BHP Mitsubishi Alliance

Supplementary information in response to IESC
comment

To: Hannah Silcox
From: Scott Weeks, Dave Western
Company: BMA
SLR Consulting Australia
cc:
Date: 8 October 2025
Project No. 620. 040484.00002
RE: Saraji Mine Grevillea Pit Continuation Project – Groundwater Impact Assessment IESC Advice Response

UPDATED THICKNESS OF THE PHILLIPS CREEK ALLUVIUM

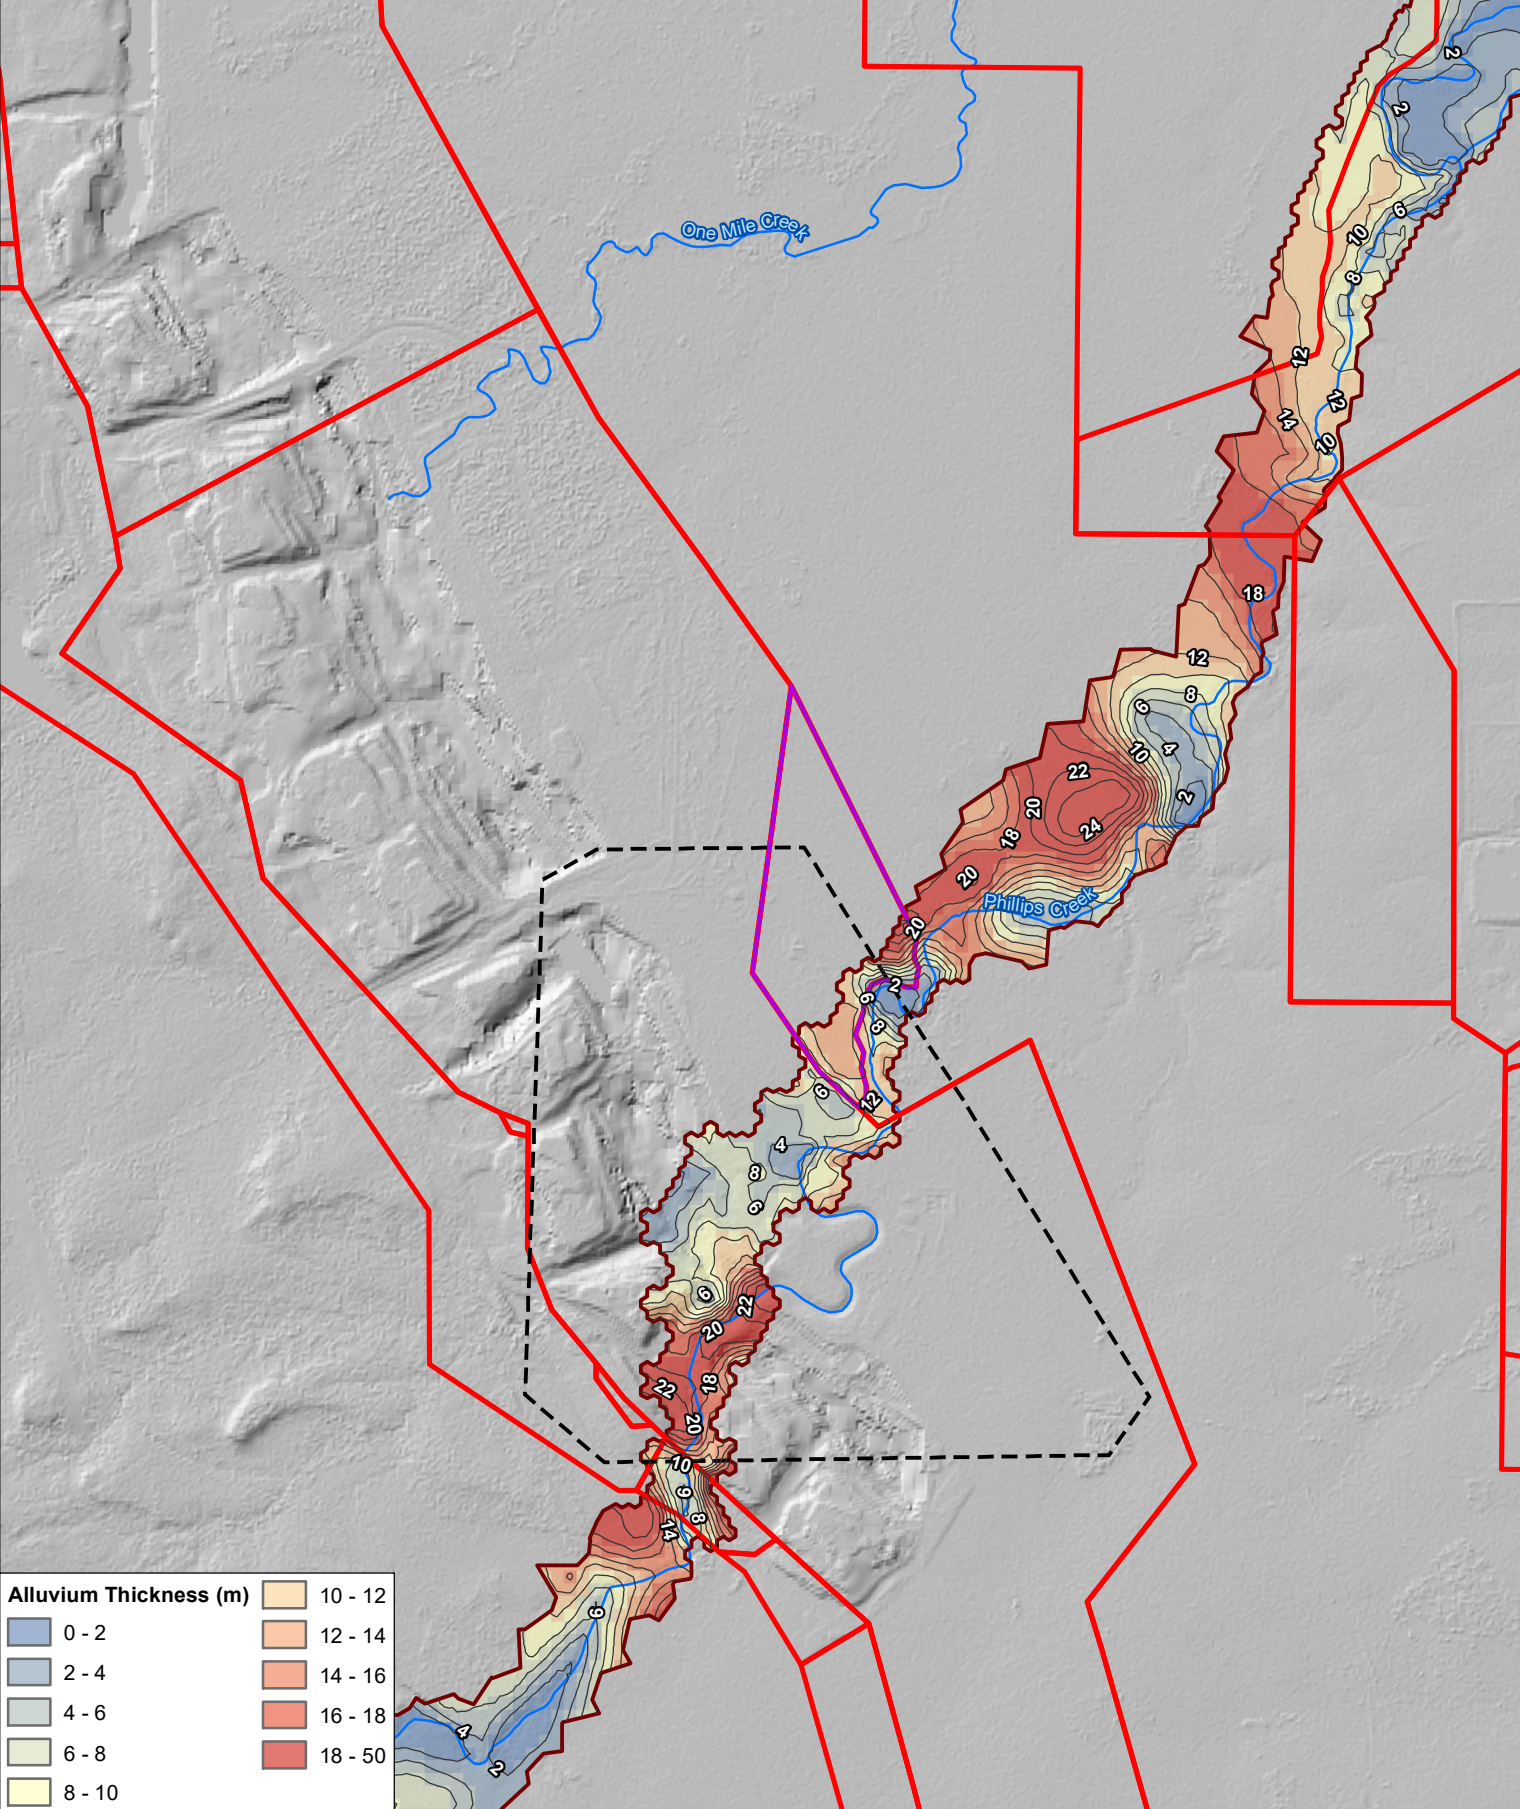
Appropriate field data, including surveying and mapping, are needed to characterise the extent, thickness, and hydrogeological characteristics of the Quaternary alluvium along Phillips Creek and within the project area, including potential lateral and vertical hydraulic connectivity within the alluvium, and with the Tertiary sediments and Permian coal seams.

In the Phillips Creek alluvium, there has been no material change in the interpreted lateral extent. However, changes in thickness ranging between -6m (i.e., the alluvium is now thinner) and 5m (i.e., the alluvium is now thicker) were identified, with the maximum thickness of the alluvium in the vicinity of the Project being approximately 22m. The revised thickness of the Phillips Creek alluvium therefore ranges from 0.8m to 22m (see **Figure 1**). This range is similar to those of the alluvium aligned along Plumtree and Boomerang Creeks to the north and Downs Creek to the south.

Figure 3 Impact pathway diagram

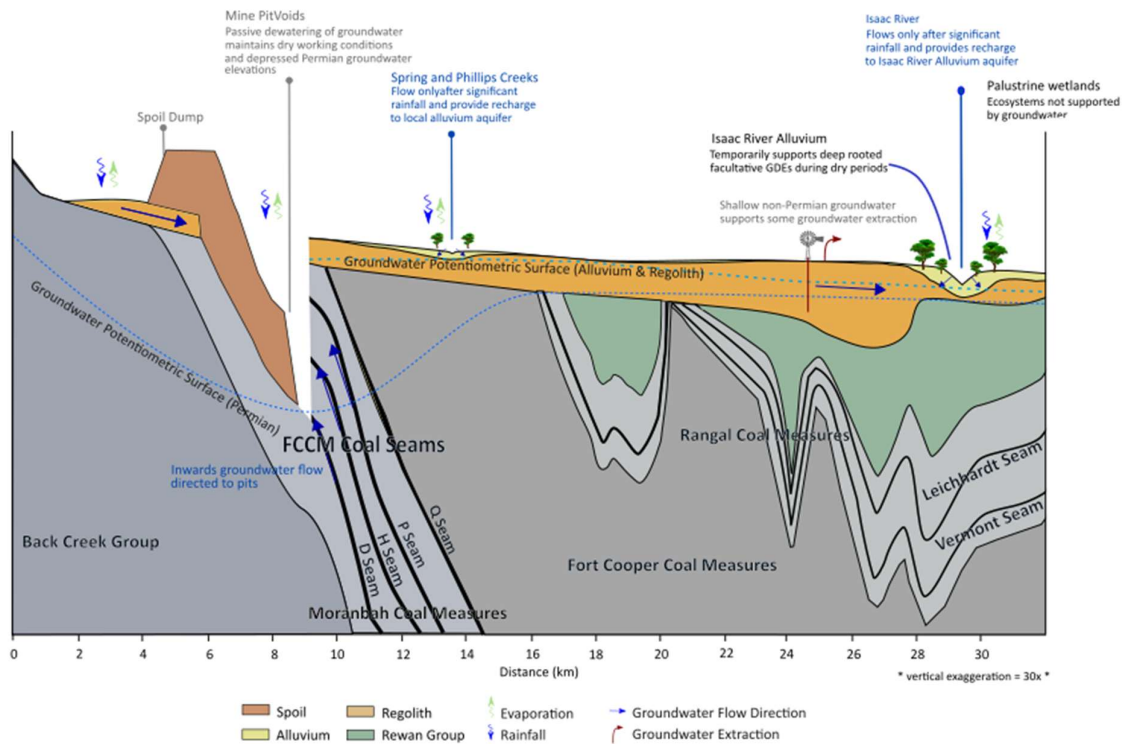
Once further data have been collected, an impact pathway diagram should be developed to refine the understanding of how and where the project may impact water resources within and near the project area. This will assist in developing appropriate monitoring programs and management plans.

As discussed in **Section 1.1.1**, there has been no change in the understanding of the conceptualisation and by inference the impact pathway. The impact diagram shown in **Figure 3** shows there is a lack of a hydraulic pathway between the Project and the Phillips Creek alluvium (which is dry, shown in yellow) and Phillips Creek, with the potentiometric surface residing in the regolith. Therefore, there is no potential for the Project to impact water resources associated with the alluvium and creek.

CUMULATIVE DRAWDOWN AT END-OF-MINING IN ALLUVIUM

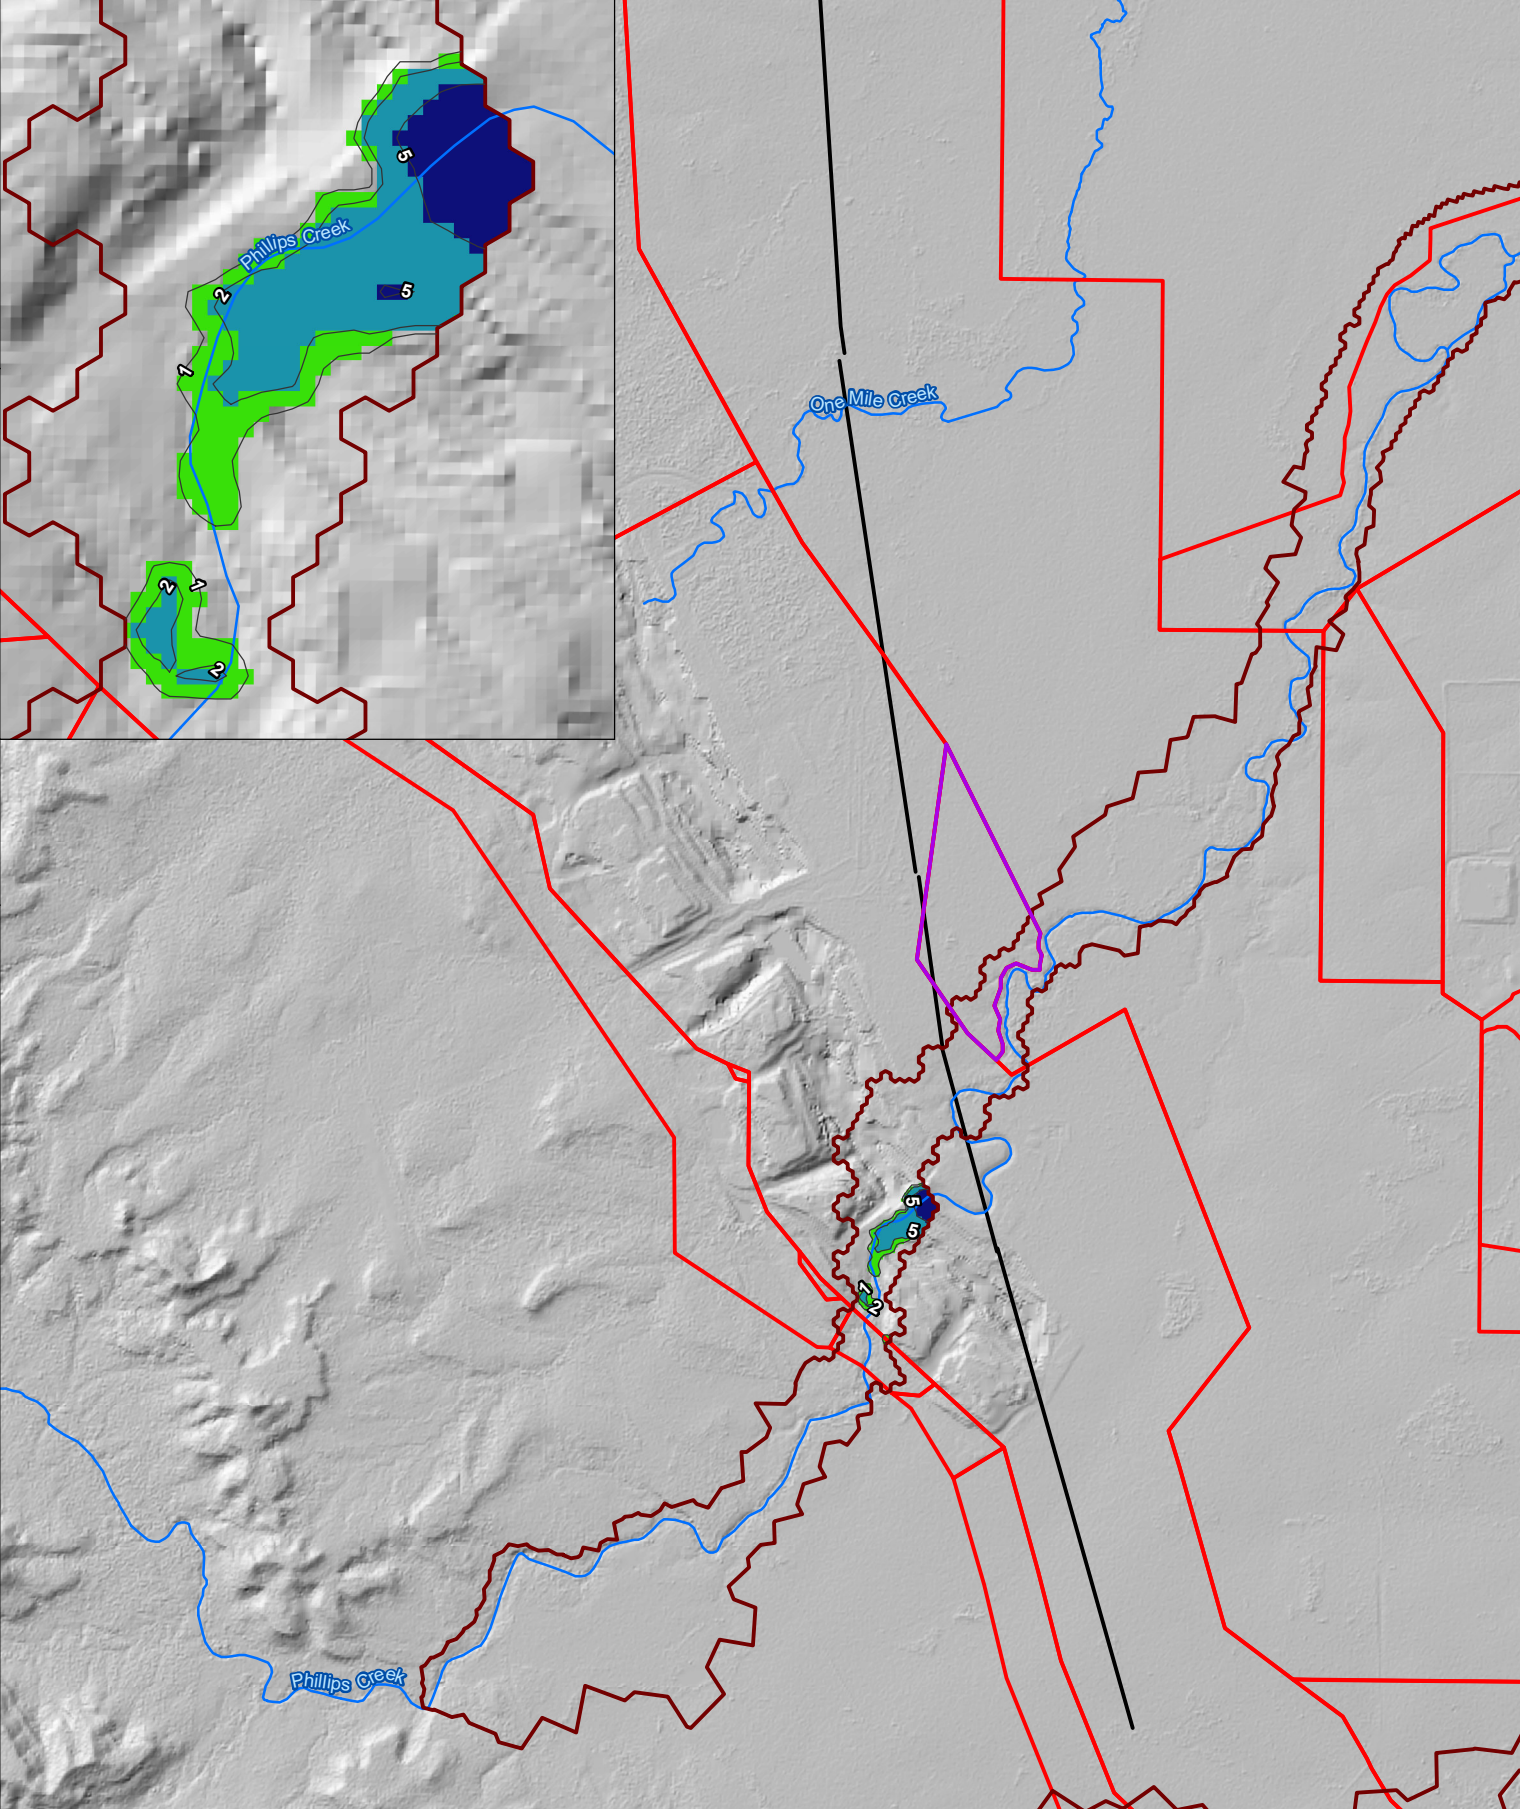
The revised conceptualisation (Paragraph 3) should be used to inform whether local-scale groundwater modelling would assist in predicting changes in water levels in the alluvium during and after mining, to improve predictions of impacts to Phillips Creek and tGDEs.

Figure 4 shows the groundwater drawdown in the alluvium at the end of mining for the cumulative scenario (all mining including Project – scenario 3). In the vicinity of the Project, drawdown in the alluvium is restricted to 5m in a small area south of the Project.

POST MINING LANDFORM

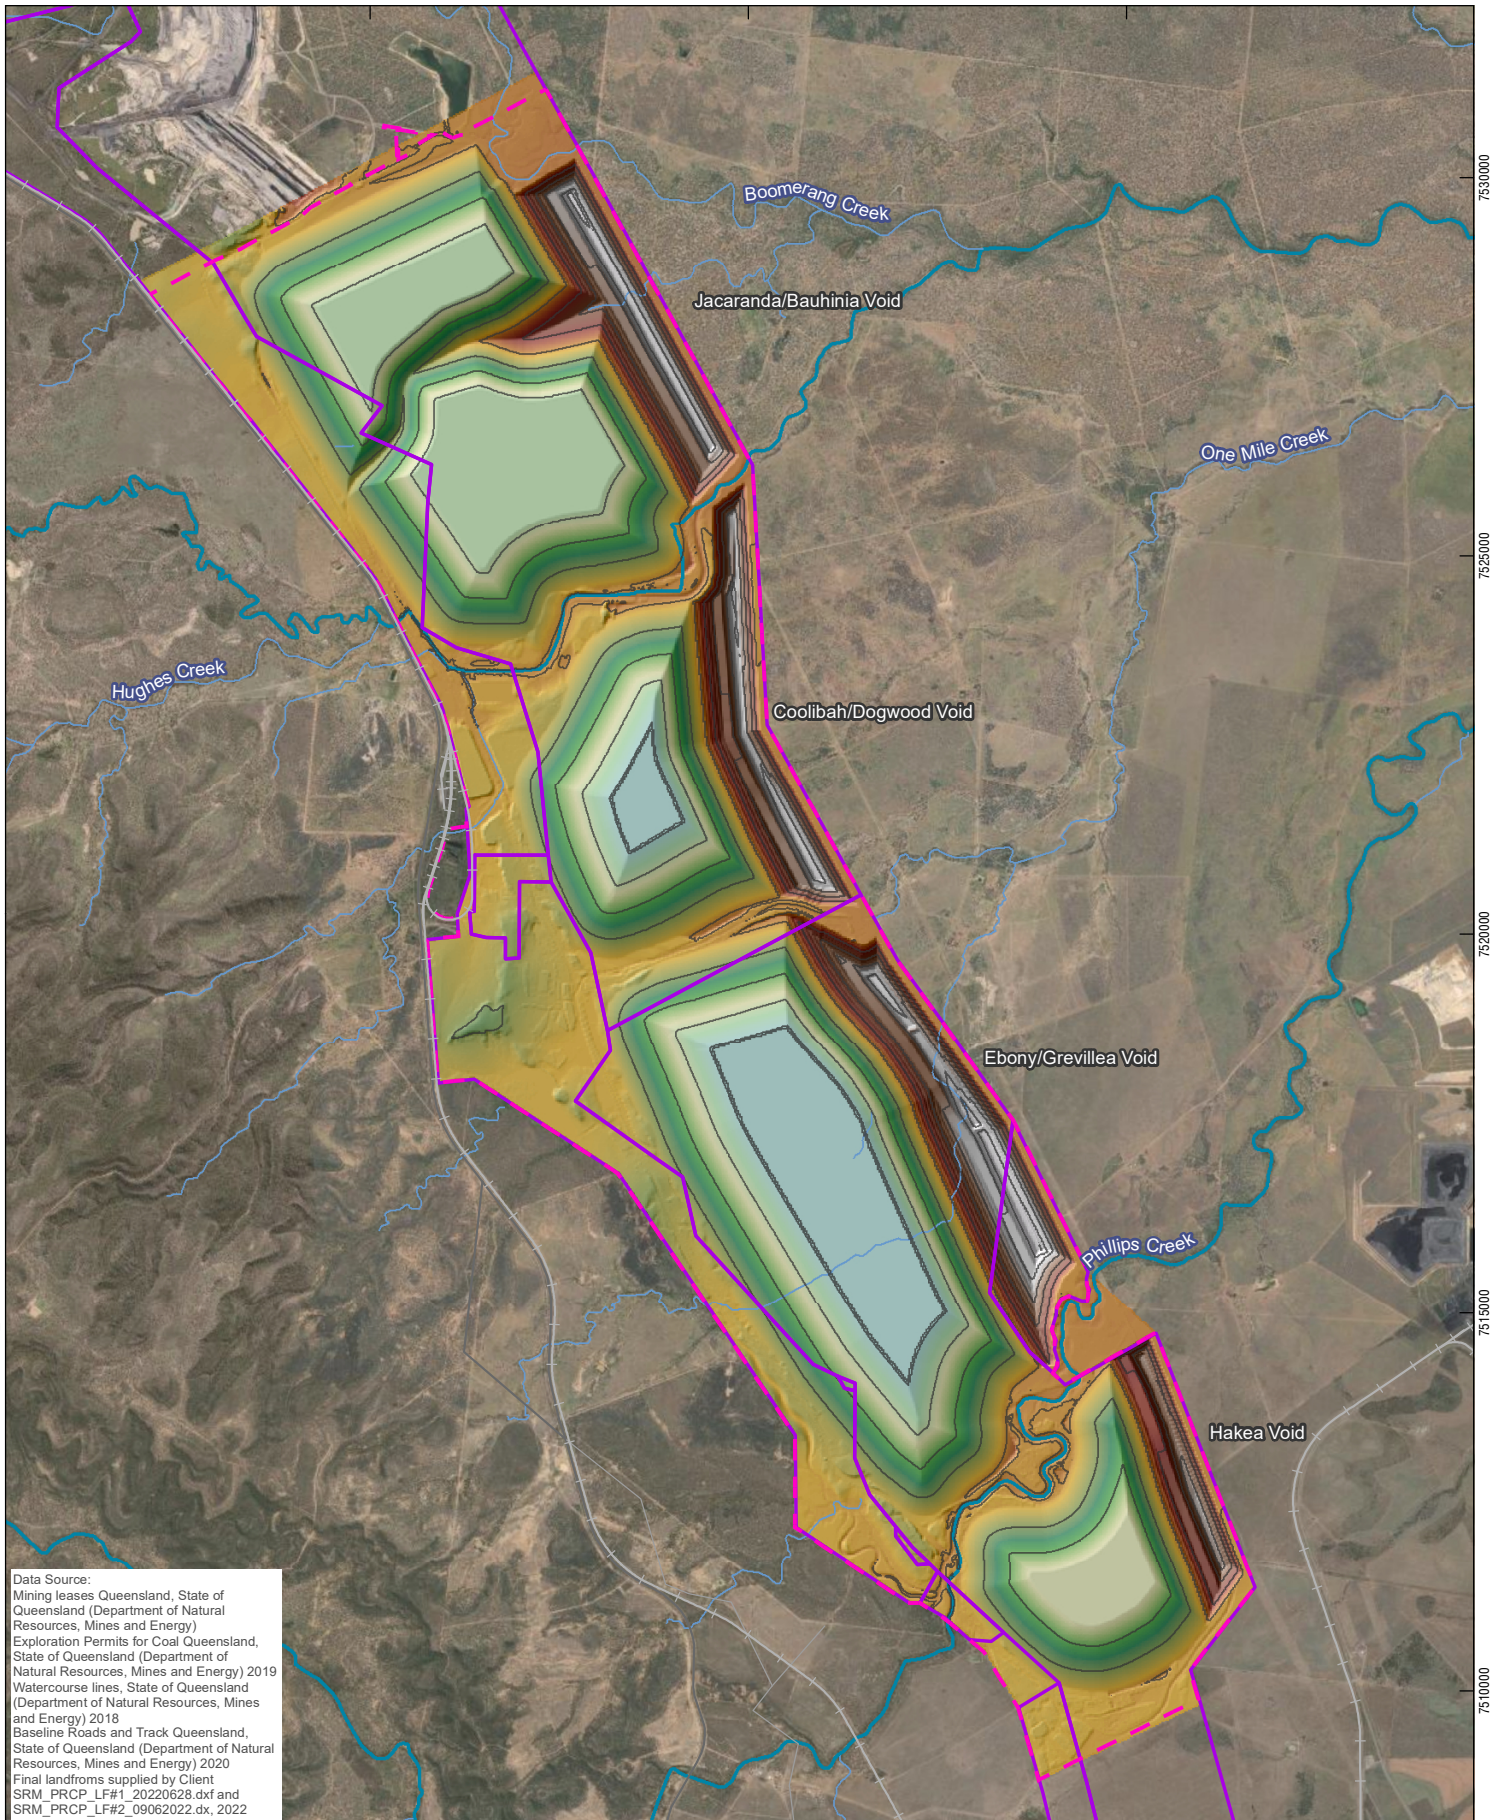
Additional groundwater modelling should estimate and clearly document the long-term impacts of the proposed final void and the increased recharge of spoils.

The post-mining final landform contains four residual final voids: Jacaranda/Bauhinia Void, Coolibah/Dogwood Void, Ebony/Grevillea Void, and Hakea Void (Acacia Pit will be backfilled with spoil) as shown in **Figure 17**.
